# Service Bulletin

Subject: RM250/370 GENERAL MAINTENANCE

Bulletin No: RM-19  
Date: Feb. 27, 1976

**RM-20**

## CYLINDER PORT CHAMFER:

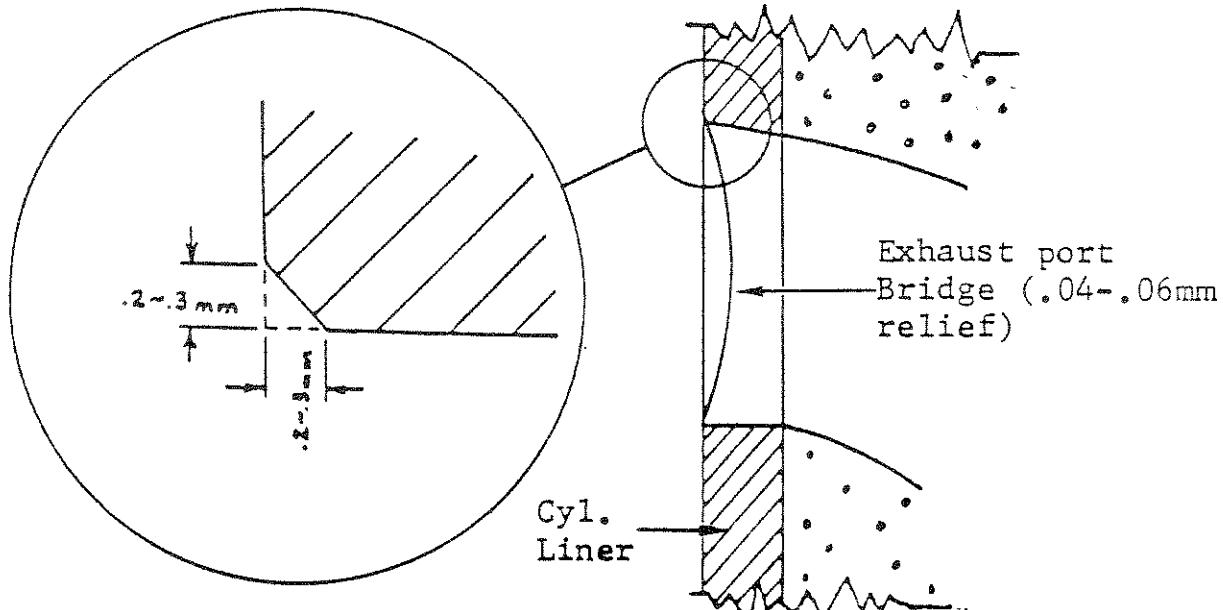
Whenever inspecting an RM250 or RM370's cylinder port chamfer, you will notice that the chamfer is very slight as compared to other Suzuki models. Both the vertical and horizontal dimensions of the chamfer should be  $.2\text{-.3mm}$ , as shown below:

Subject: RM100 PRIMARY DRIVE/DRIVEN GEARS

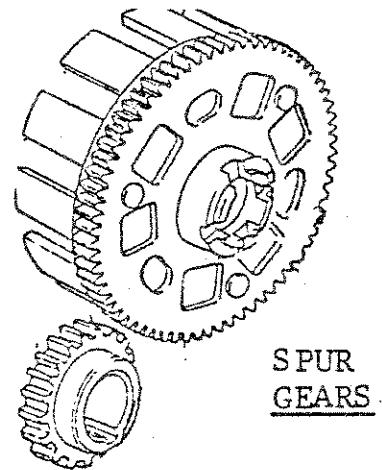
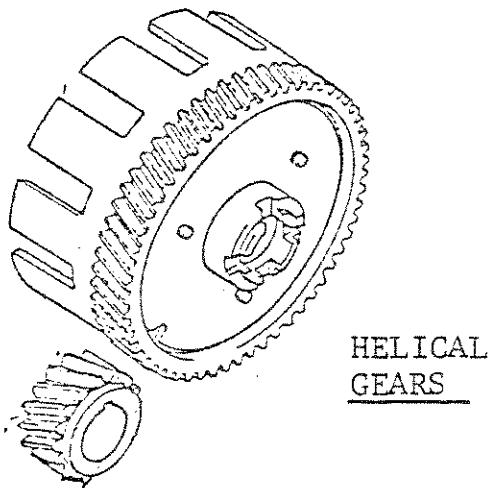
The mechanical efficiency of the RM100's primary drive and driven gears has been increased. This has been accomplished by changing the design of the helical type gears to spur type gears (commonly referred to as straight cut gears).

Spur type primary drive and driven gears are installed on RM100's on and after the following Engine Number: RM100-11445.

Due to the major change in design, the individual gears are not interchangeable separately. However, they are interchangeable when both drive and driven gears are changed as a set.

**RM250/370 ENGINE MOUNT  
BOLTS AND BUSHINGS**

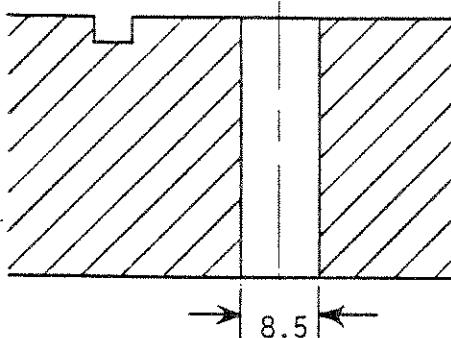
To protect RM250 and RM370's crankcases against damage resulting from lack of proper torque applied to engine mounting bolts, bushings have been added to the engine crankcases.

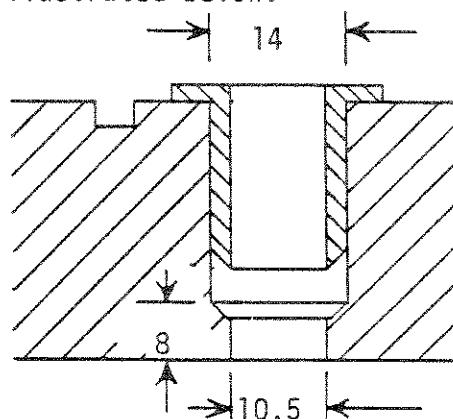
B. As of Frame Number RM250-12173 through 13750 a bushing was added to the upper rear crankcase engine mount only. The dimensions of the bushing are illustrated below.

C. As of Frame Number RM250-13751 and after, the upper rear engine mounting bolt's size was changed to 10mm. The size of the bushing was also increased to accept the new bolt as illustrated below.

The frame was also modified to accept the larger diameter bolt.

## II. RM370 (Upper and lower rear engine mount)

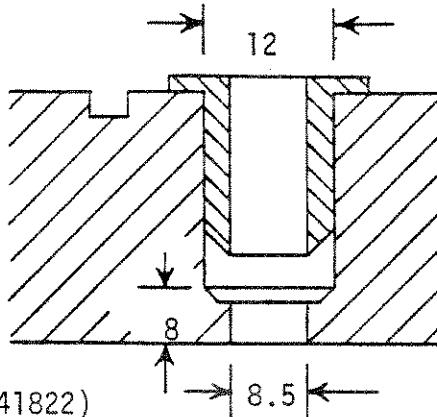
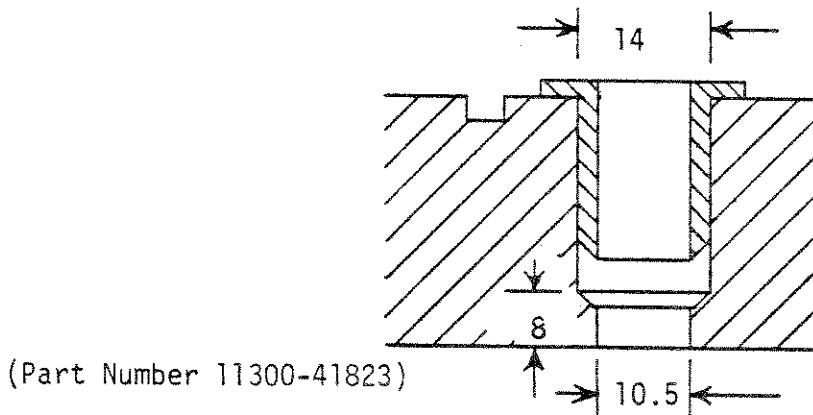
A. RM370's from initial production through Frame Number 13708, had both an upper and lower rear engine mount bushing installed. They are illustrated below.

B. As of Frame Number RM370-13109 the upper rear engine mount bolt's size was increased from 8mm to 10mm. The inside diameter of the upper rear engine mount bushing was increased to accept the larger engine mount bolt.

The frame was also modified to accept the larger diameter bolt.

Subject: RM100 FRONT BRAKE CABLE ROUTING

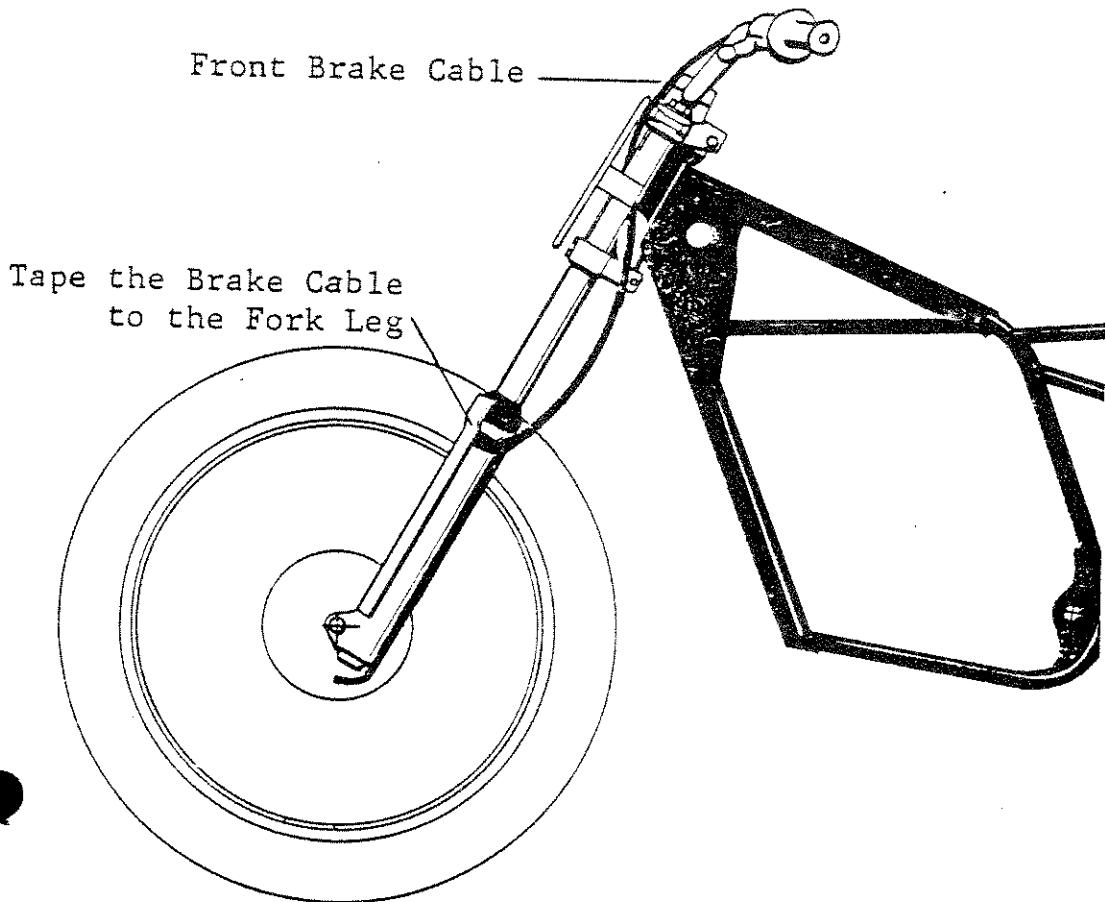
Reports have been received indicating incorrect placement of the front brake cable on the RM100. When the cable is routed in front of the front number plate, there is the possibility of the cable hanging up on the upper left fork tube securing bolt when the forks are fully compressed. If the front brake cable is adjusted tighter than normal for off road riding, the brakes can become locked.

To eliminate the possibility of this happening, be sure the front brake cable is routed behind the front number plate, and that it exits through the rear side of the steering stem. Also, be sure that the cable is taped to the lower fork leg just below the dust seal.

Service ANPSubject: 1976 RM125A IGNITION TIMING  
SPECIFICATIONS**NOTICE:**

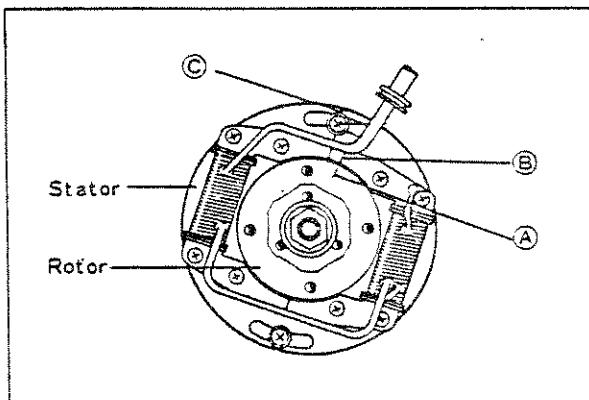
In conjunction, the ignition timing specification has been changed on the 1976 RM125A to 0.31mm BTDC ( $8^\circ$  BTDC @ 11,000 rpm.) This differs from the 1975 RM125M ignition timing specification which is 3.80mm BTDC ( $29^\circ$  BTDC @ 6000 rpm).

1. Remove the spark plug and install the Timing Guage (09931-00112). Position the piston at T.D.C. and adjust the Timing Guage to "0".
2. Turn the rotor clockwise until the Timing Guage indicates 0.31mm BTDC. Hold the piston in that position.

3. Adjust the stator so that line (A) aligns with rotor line (B). Next tighten the 2 stator base plate screws. This establishes the ignition timing as specified for the 1976 RM125A engine.

1. Loosen the two stator base plate screws.
2. Position the timing mark (C) to the center of the securing screws. This method approximates the ignition timing for this model.

Subject: 1975 RM125M KICK STARTER DRIVEN GEAR

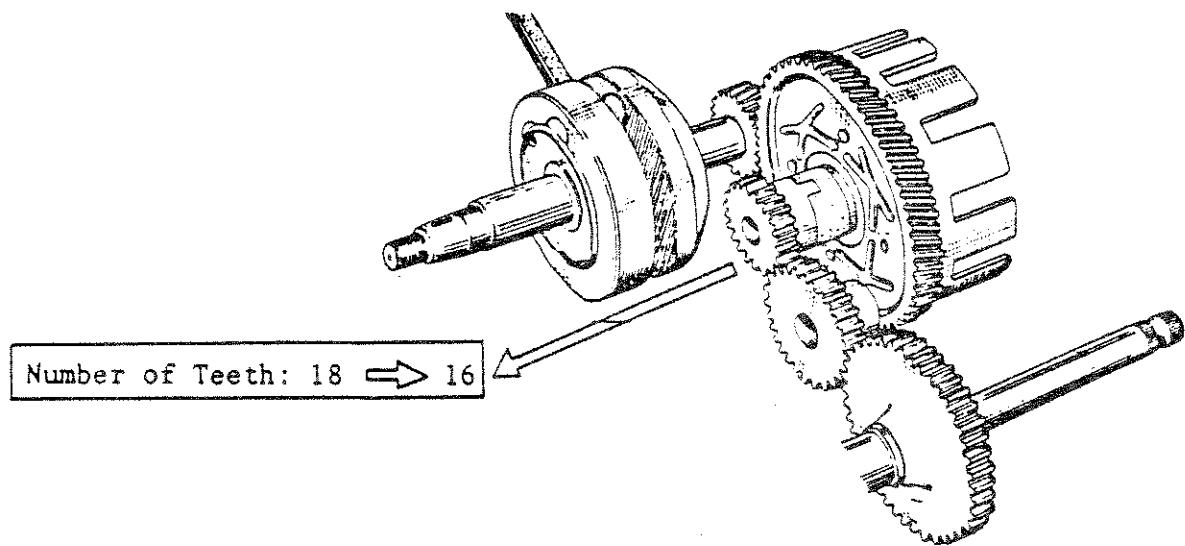
To further increase durability of the RM125 kick starter driven gear, the number of teeth on the gear has been decreased from 18 to 16.

This new style gear has been installed on and after Engine Number RM125-15145.

The old and new style parts are interchangeable. It is recommended however that when the old style part needs replacement that the new style part be used.
